ENVIRONMENTAL ASSESSMENT
OF THE
DAWN MINING COMPANY
PROPOSED BELOW-GRADE TAILINGS MANAGEMENT PLAN
FORD, WASHINGTON

AUGUST, 1980
PROJECT WM-33

PREPARED BY THE
U. S. NUCLEAR REGULATORY COMMISSION
WASHINGTON, D.C.

FOR THE DEPARTMENT OF SOCIAL AND HEALTH SERVICES
STATE OF WASHINGTON
TO DOCUMENT TECHNICAL ASSISTANCE
BEING PROVIDED IN CONNECTION
WITH THE LICENSING OF THE
PROPOSED TAILINGS MANAGEMENT PLAN

Figure 3.4. Typical Section of North Side of Pit (Source: Reference 3)

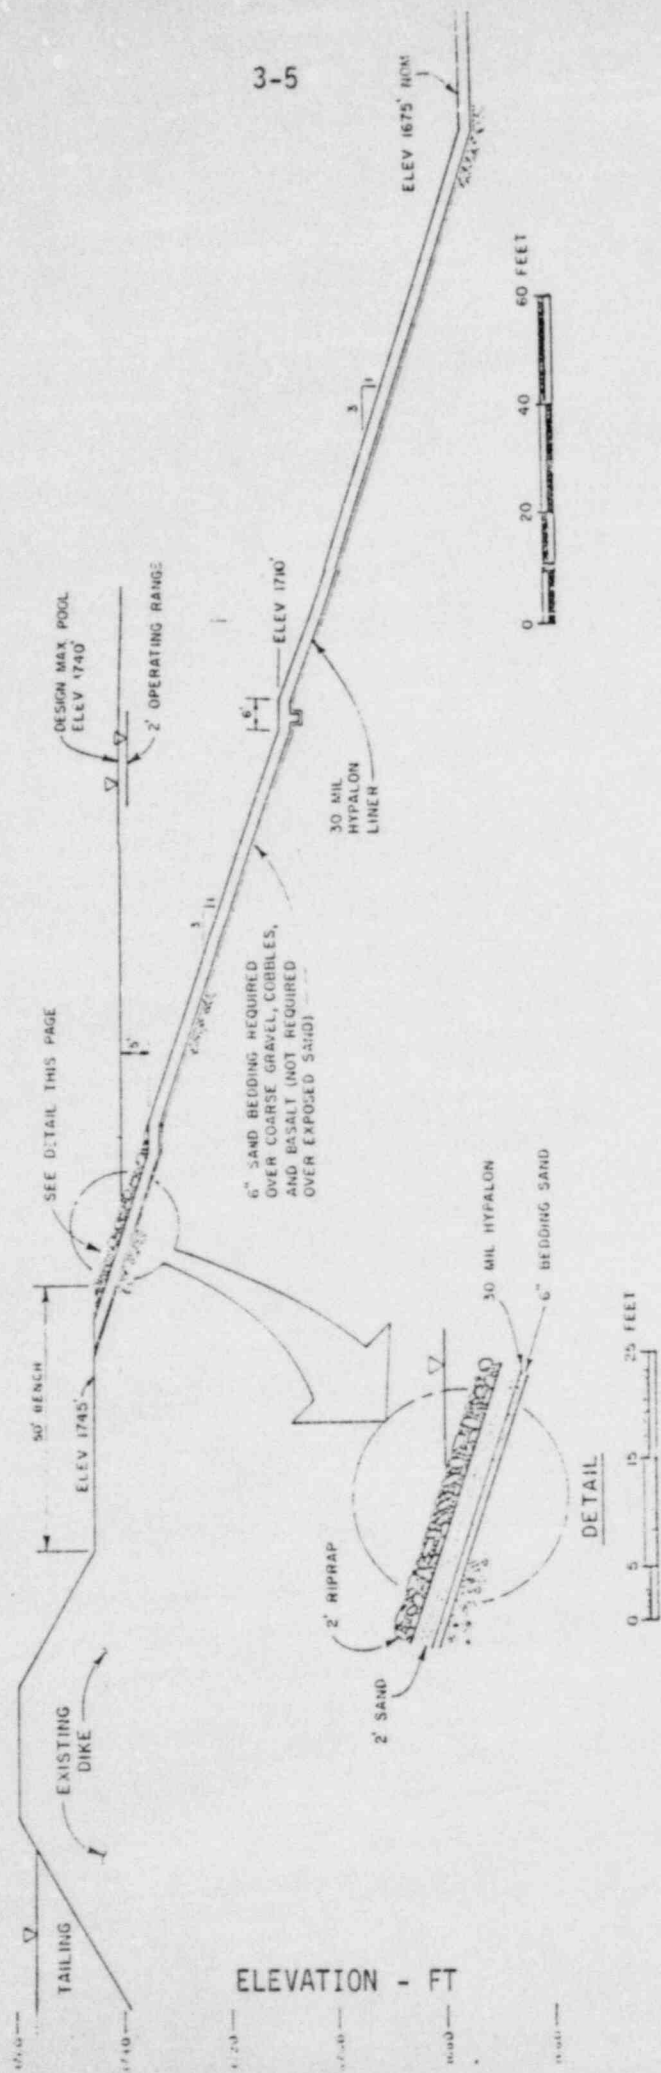
The general layout of the pit is shown in Figure 3.5. As shown in Figure 3.4, the slopes of the pit will typically be 3h:1v and the upper 10 feet (3 m) (vertical distance) of the slope will be covered with riprap to protect against wave action.

The upper 10 feet (3.0 m) of the embankment (that is, elevation 1735 to 1745) will be riprapped to ensure embankment protection from wave action as shown in Figure 3.4. Consequently, wind and wave damage should be minimal. Because of the wave protection and the extreme conservatism with which the PMF was estimated by the applicant, the NRC staff recommends that the proposed 5 feet (1.52 m) of freeboard be considered adequate.

Figure 3.6. Drainpipe Installation Details (Source: Reference 3)

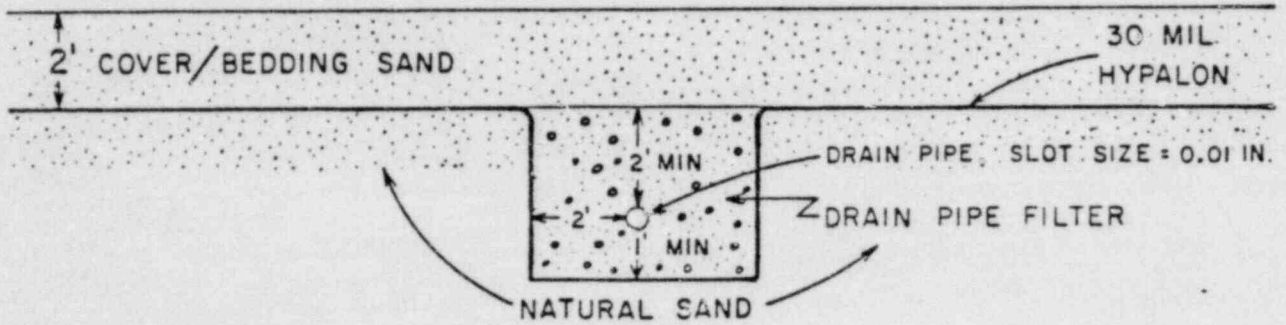
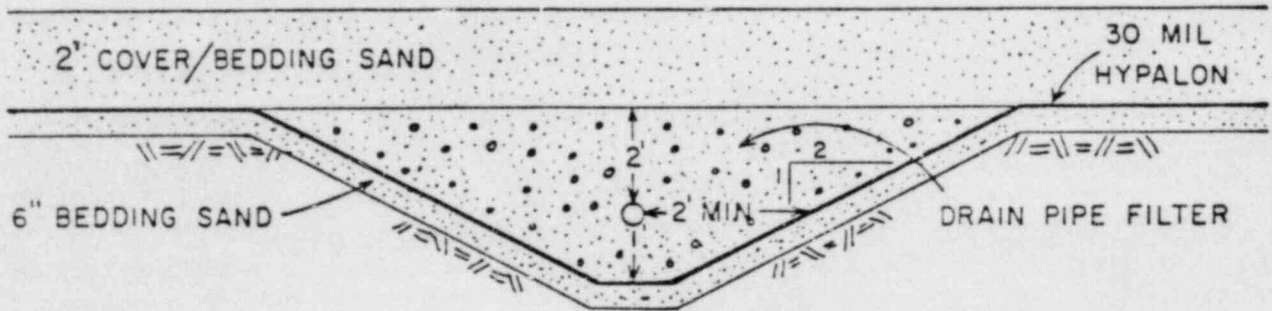
The underdrain system shown in Figure 3.6 indicates various zones of sand and bedding material and tailings in contact with one another. The grain size distribution curves for these materials shown in Reference 3 were stated to have been designed on the basis of Corps of Engineers criteria. However, using the criteria detailed in the Pit Slope Manual (Ref. 12), an independent analysis by NRC staff indicated that for both the bedding and the drain pipe filter, criteria governing segregation of grain sizes have not been met. Although failure of the underdrain system does not present an environmental or safety hazard, all filter criteria should be met if an effective system is to be ensured.

5. Using filter design criteria as detailed in Reference 12, an independent analysis of the underdrain system by the NRC staff indicates that for both the bedding and the drain pipe filter, criteria governing segregation of grain sizes have not been met. Filter criteria must be met to assure an effective and reliable system.
